Transitional Care Facility

Stage 1 & 2 Road Safety Audit

Bartra Property Cookstown Limited

February 2023

Figure 2.1 – Example Pedestrian Crossing Location with High Containment Kerbs

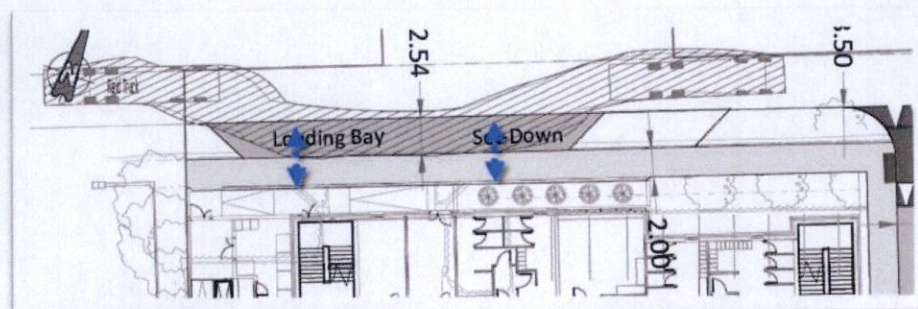
2.1 Problem: High Containment Kerbs / Footpath Gradients

Location: Sheet 1 of 6 | All Site Access Points and Road Crossings

The existing high containment kerbs create a difference in level between the footpaths and the road pavement which could lead to steep gradients and pedestrian progression issues at the site accesses and various pedestrian crossing points.

Appropriate footpath gradients should be provided at the site access points and pedestrian crossing locations.

2.1	Yes	Yes	Appropriate transition kerbs have been added and suitable gradients will be maintained as part of any design.	<i>Noted</i>
2.2	Yes	Yes	The kerbing along the development boundary is to be replaced with standard height kerbs.	<i>Noted</i>

Figure 2.3 – Existing Crossing to be Facilitated

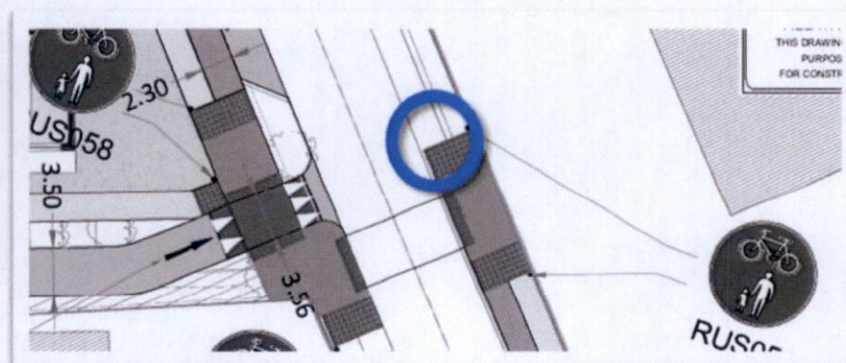
2.3 Problem: Maintaining Existing Crossing Desire Line

Location: Sheet 1 of 6 | Roundabout Beside North East Corner of Site

Failing to facilitate the existing courtesy pedestrian crossing at this location could lead to walkers crossing at places where it is less safe to do so.

Provision should be made to facilitate the existing pedestrian crossing.

2.3	Yes	Yes	The proposed layout has been amended to maintain and incorporate this crossing	<i>Noted</i>
2.4	Yes	Yes	The proposed layout has been amended to include appropriate kerbing at this location to close off the parking bay.	<i>Noted</i>

Figure 2.4 – Area Where Vehicles Could Enter Shared Surface Whilst Parking

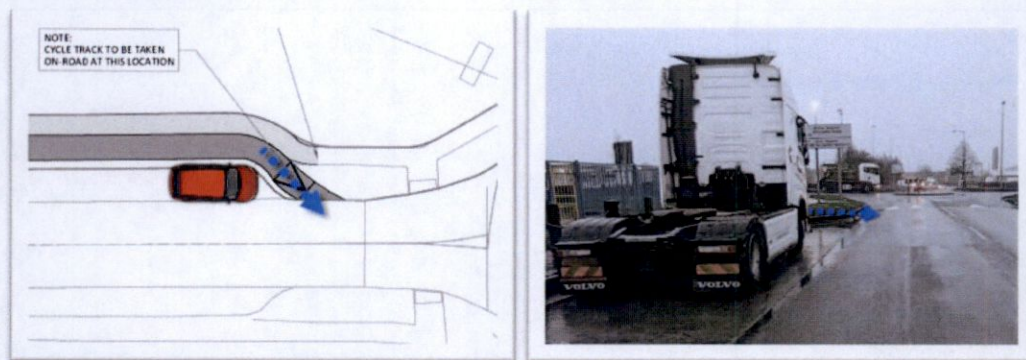
2.4 Problem: Conflict Between Parking Area & New Crossing Point

Location: Sheet 1 of 6 | New Courtesy Crossing to South East Corner of Site

Without containment, vehicles manoeuvring into or out of the parallel parking spaces could roll into the shared surface, placing pedestrians at risk of conflict.

Appropriate containment measures should be set in place to mitigate the risk of vehicles rolling into the shared surface.
